**Committee of Experts on the Transport of Dangerous Goods
and on the Globally Harmonized System of Classification
and Labelling of Chemicals****Sub-Committee of Experts on the Transport of Dangerous Goods****Fifty-fifth session**

**Miscellaneous proposals for amendments to the
Model Regulations on the Transport of Dangerous Goods:
marking and labelling****Optical differentiation of labels/placards for gases****Submitted by the expert from Spain and the International Association
of Fire and Rescue Services (CTIF)*****Introduction**

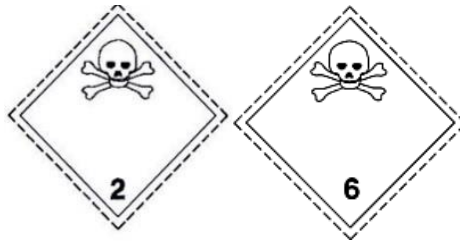
1. For different labels corresponding to different classes, the labels are only differentiated by the numbers indicated in the lower part of the label. This occurs for labels 2.1 and 3, and labels 2.3 and 6:

9. Labels 2.1 and 2.3 have the same colour and symbol (flame and crossbones) like labels 3 and 6, and the only difference is the class number indicated in the lower part of the label. The labels could be differentiated from others by including an additional symbol into the labels. This symbol included into the labels lower part could be the gas cylinder that is now included into label 2.2, and is well known and identified as gas:

10. This symbol could be included into the lower half of the labels; including a symbol into the lower half of the label has already been done for the 9A label. A possible design could be as follows:

15. The expert from Spain and CTIF propose to modify labels 2.1 and 2.3 to include the gas receptacle symbol into the lower part of the label.

16. Therefore, the expert from Spain and CTIF propose to modify 5.2.2.2.2 for label numbers 2.1 and 2.3. Deleted text is ~~stricken through~~, new text is underlined; for the specimen labels of labels 2.1 and 2.3, only the new labels are shown, as it is not possible to strike through or underline the labels in the existing text.

Label model No.	Division or Category	Symbol and symbol colour	Background	Figure in bottom corner (and figure colour)	Specimen labels	Note
Class 2: Gases						
2.1	Division 2.1: Flammable gases (except as provided for in 5.2.2.2.1.6 d))	Flame <u>in upper half:</u> black or white <u>Gas cylinder in lower half:</u> black or white	Red	2 (black or white)		-
2.2	Division 2.2: Non-flammable, non-toxic gases	Gas cylinder: black or white	Green	2 (black or white)		-
2.3	Division 2.3: Toxic gases	Skull and crossbones <u>in upper half:</u> black <u>Gas cylinder in lower half:</u> black	White	2 (black)		-
